Access Compliance Report Public Rights-of-Way (Curb Ramps)

Main Street: HUNTER_LN Cross Street: BOLSA_AVE Location: SW

ADA ID: RPRK211005134106 Ramp Type: Type 1 - Perpendicular Diagonal Initial Pass/Fail: Fail Overall Compliance: No Severity Score: 15

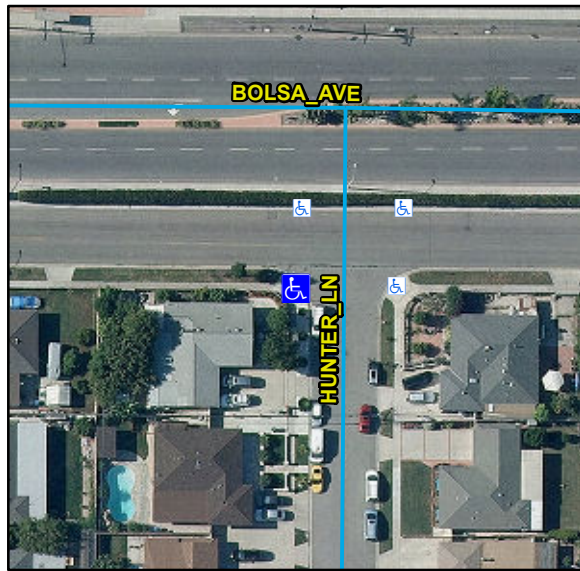
Compliance	Description	Data	Compliance	Description	Data
N/A	Ramp Length (in)	98	N/A	Flare Type LT	
Yes	Ramp Width (in)	48			N/A
No	Ramp Run Slope (%)	11.1	N/A	Flare Slope LT (%)	N/A
Yes	Ramp Cross Slope (%)	0.3	N/A	Flare Traversable LT	N/A
N/A	Landing Present	N/A	N/A	Flare Type RT	
N/A	Landing Length (in)	N/A			N/A
N/A	Landing Width (in)	N/A	N/A	Flare Slope RT (%)	N/A
N/A	Landing Run Slope (%)	N/A	N/A	Flare Traversable RT	N/A
N/A	Landing Cross Slope (%)	N/A	N/A	DWS Provided	N/A
N/A	Landing Movement Obstructed?	N/A	N/A	DWS Contrast	N/A
	Landing Movement Type	N/A	N/A	DWS Length (in)	N/A
N/A	Landing Shared	N/A	N/A	DWS Full Width	N/A
N/A	Clear Space	Yes	N/A	DWS Offset Left (in)	N/A
N/A	Clear Space To Crosswalk (in)	N/A	N/A	DWS Offset Right (in)	N/A
N/A	Marked Crosswalk 1	No	N/A	Marked Crosswalk 2	No
	Crossing 1 Direction	E		Crossing 2 Direction	N
	Marked Crosswalk 1 Width (in)	N/A		Marked Crosswalk 2 Width (in)	N/A

Remove & Replace Curb Ramp With Two New Directional Ramps or Equivalent.
